RE: DRAINAGE PLAN FOR AN ADDITION TO MTSO CELLULAR ONE (K17-D68)
ENGINEER'S STAMP DATED 3/14/97

GRADING AND DRAINAGE PLAN

SITE NAME
 ALBUQUERQUE
 MTSO
 STREET ADDRESS
 145 QUINCY ST. NE
 ALBUQUERQUE, N.M.

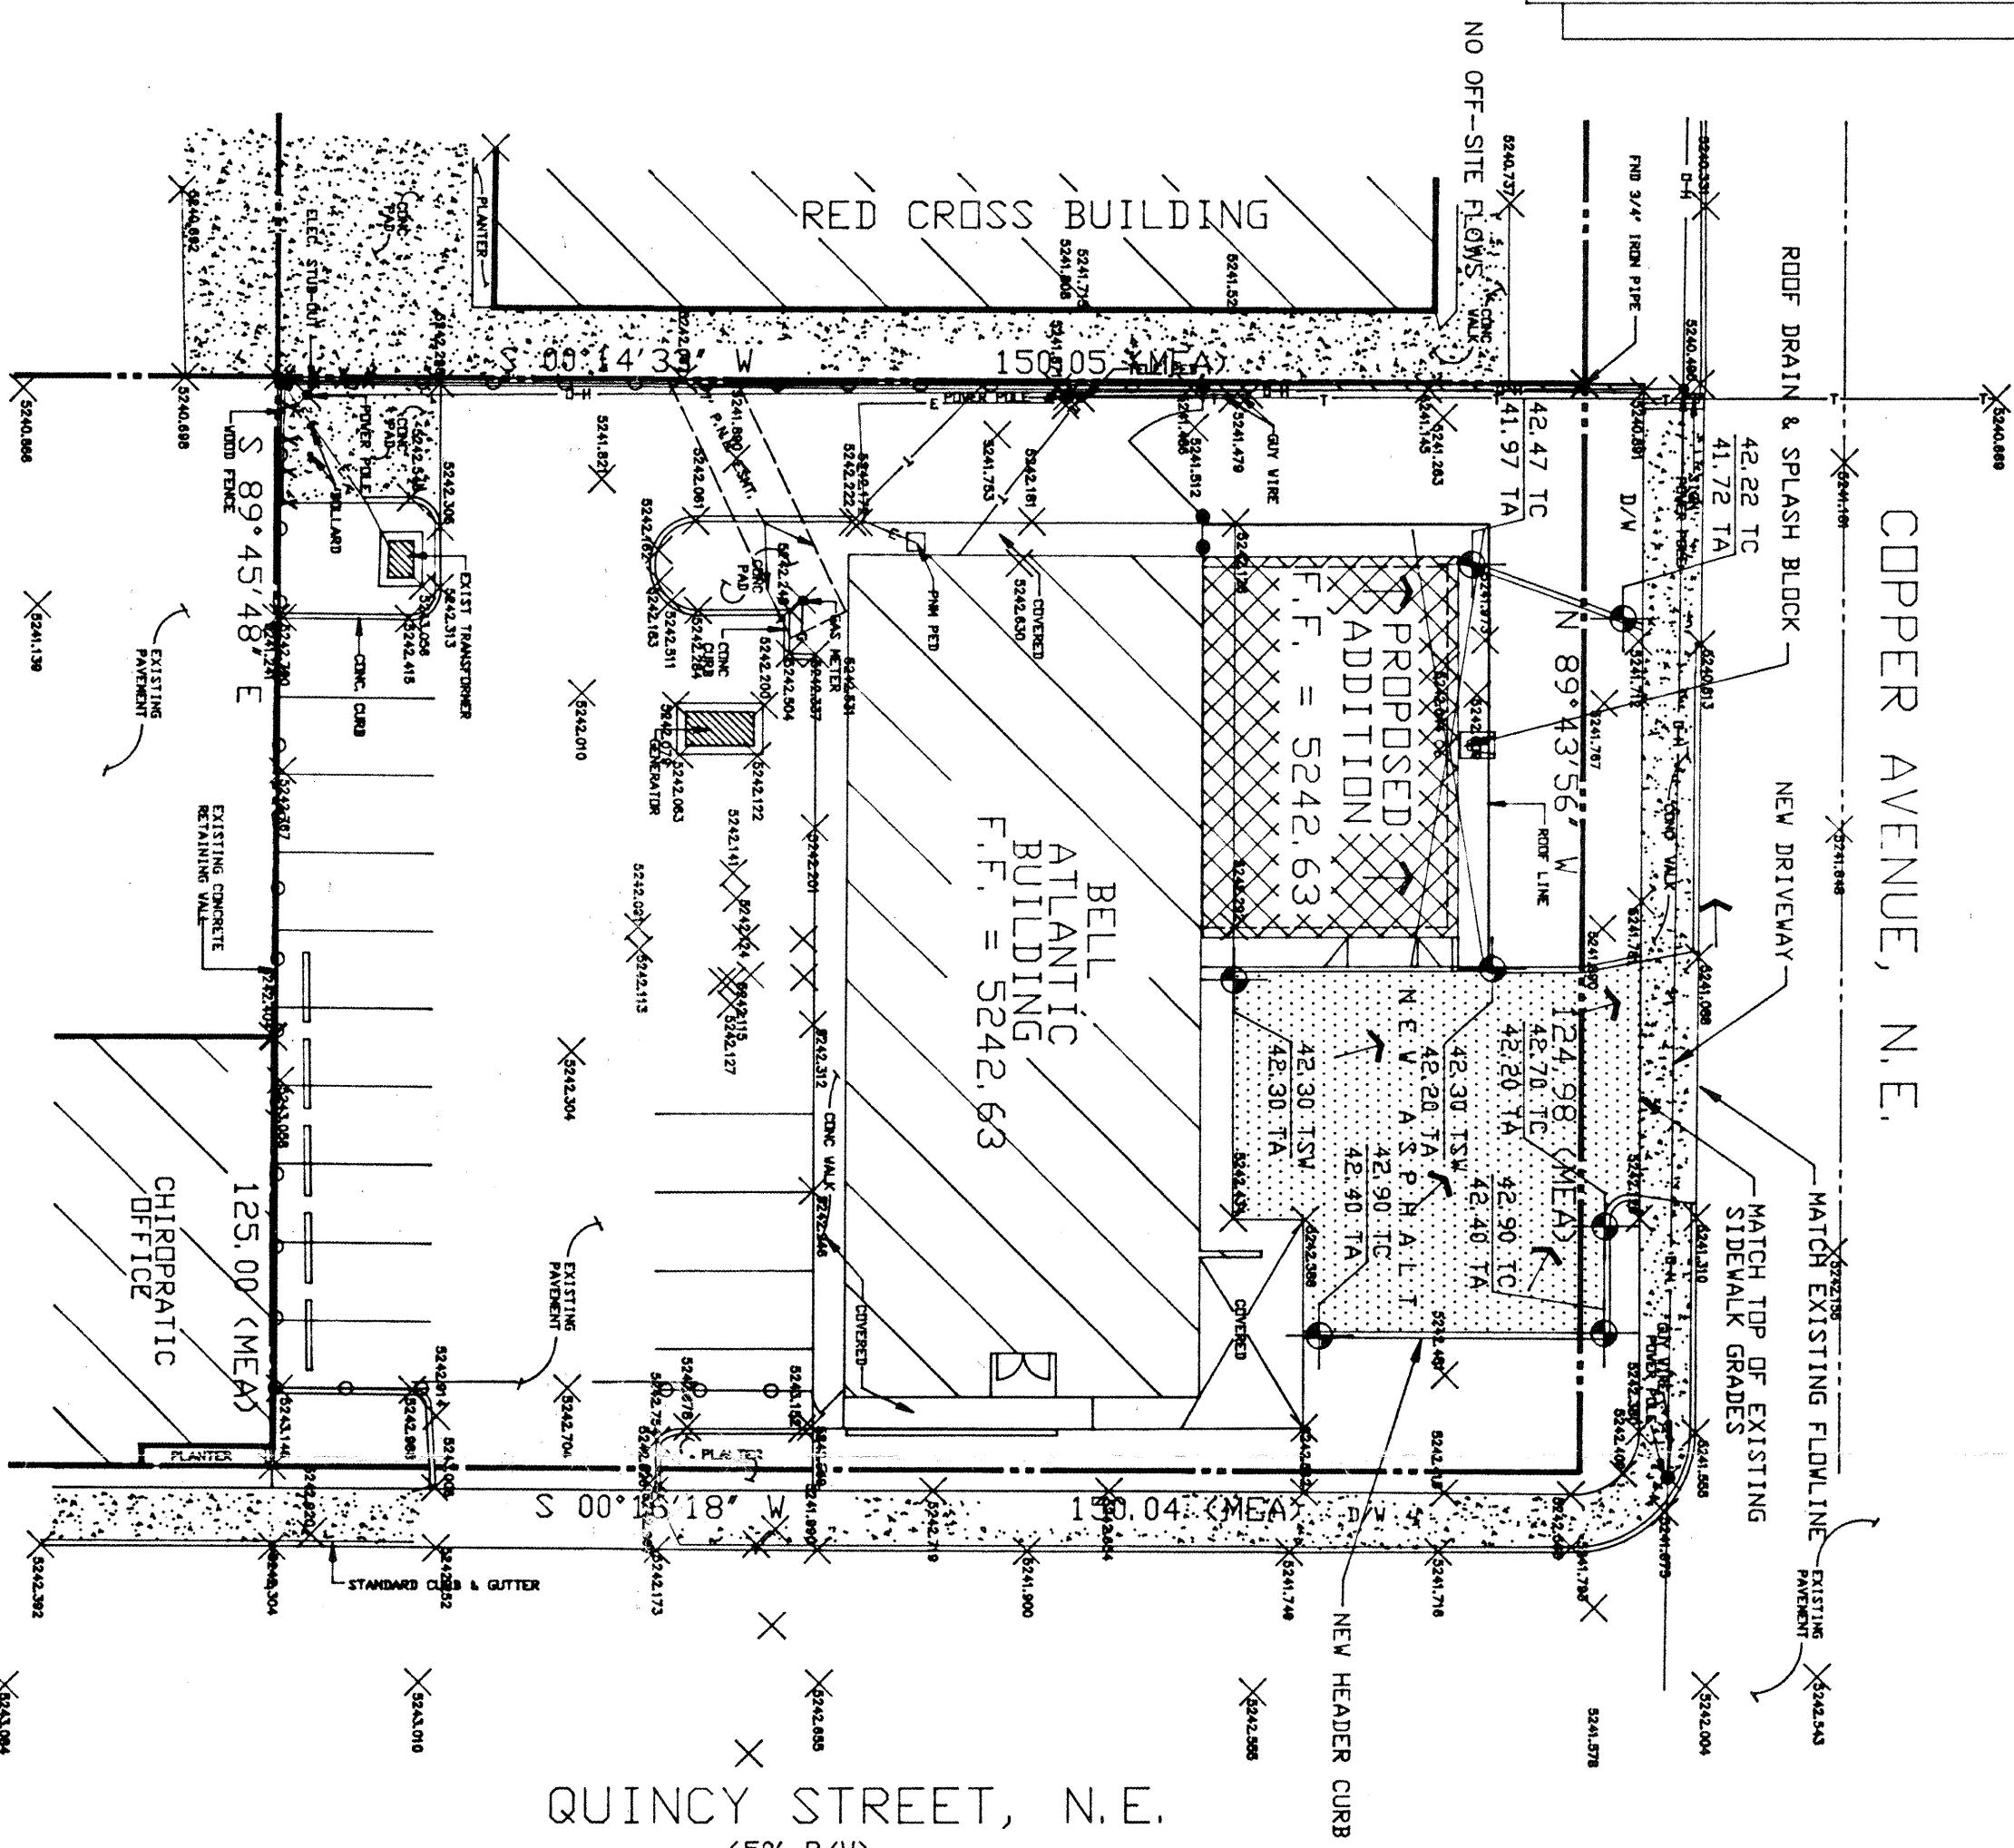
Based on the information provided on your March 14, 1997 submittal, the above referenced site is approved for Building Permit.

Please attach a copy of this approved plan to the construction sets prior to sign-off by Hydrology.

Also, prior to Certificate of Occupancy release, Engineer Certification per the DPM will be required.
